Application	No.	Applicant(s)					
Office Action Summan	10/797,337		SOH, SUNG KUR	<				
Office Action Summary	Examiner		Art Unit					
	Jon A Szumi		3632					
The MAILING DATE of this communication app Period for Reply	pears on the c	over sheet with the c	orrespondence ad	ldress				
A SHORTENED STATUTORY PERIOD FOR REPL' THE MAILING DATE OF THIS COMMUNICATION. - Extensions of time may be available under the provisions of 37 CFR 1.1: after SIX (6) MONTHS from the mailing date of this communication. - If the period for reply specified above is less than thirty (30) days, a reply - If NO period for reply is specified above, the maximum statutory period v - Failure to reply within the set or extended period for reply will, by statute, Any reply received by the Office later than three months after the mailing earned patent term adjustment. See 37 CFR 1.704(b).	36(a). In no event, y within the statutor will apply and will e	however, may a reply be tim y minimum of thirty (30) days gire SIX (6) MONTHS from to	ely filed will be considered timel the mailing date of this co	y. ommunication.

This is the second office action for application number 10/797,337, Height Adjustable Support for Furni

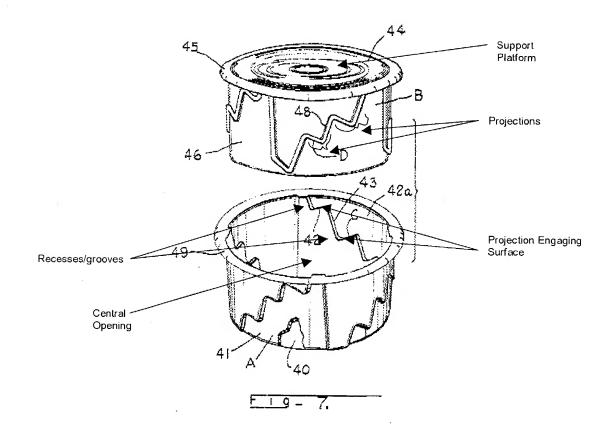
Claims 1, 2, 5, 9, 10 and 13 are rejected under 35 U.S.C. 102(b) as being anticipated by U.S. Patent number 5,599,258 to Stone et al.

Stone et al. '258 discloses a support apparatus (above) comprising a base (A) and a cradle (B) which operatively engages the base so as to be supported thereby, the cradle having a plurality of integral projections (above) formed thereon and extending outwardly from an outer wall/surface thereof, and the base having a plurality of recesses/grooves (above) formed in an inner wall thereof which are configured to mate with the projections on the cradle when the base and the cradle are operatively engaged, each of said recesses having a projection-engaging surface (above), the recesses being divisible into groups in which each recess in a group has its projection-engaging surfaces located at substantially the same level;

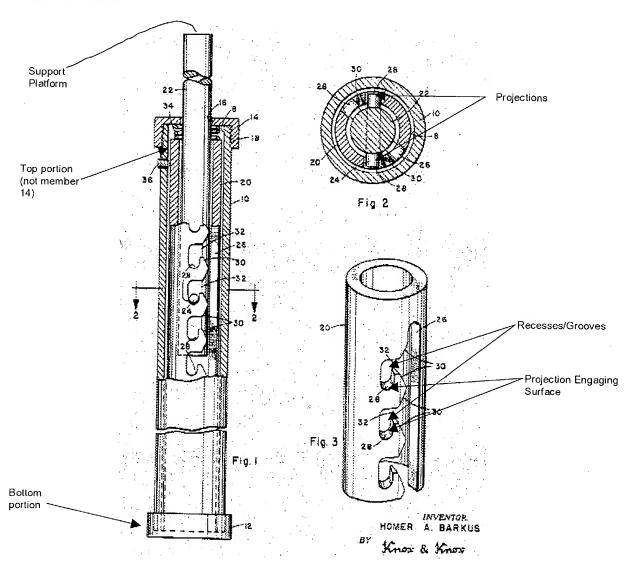
wherein adjacent recesses have projection-engaging surfaces located at different

elevational levels from one another, wherein the cradle includes a support platform (above) extending horizontally thereacross; and further wherein said base and said cradle are rotatably adjustable relative to one another, to variously engage the projections and recesses and thereby establish multiple different height positions of the cradle support platform;

wherein the base comprises a hollow base body having a central opening (above) formed therein to receive the cradle, wherein the opening defines the inner wall of the base, wherein opposite grooves located substantially 180 degrees from one another have corresponding floor portions disposed at substantially the same height, wherein the cradle has a plurality of vertically spaced apart projections extending outwardly from the cradle body (the projections are in fact spaced apart in a vertical direction), wherein the base is adapted to simultaneously support the plurality of vertically spaced-apart projections thereon, wherein the cradle body is substantially cylindrical.
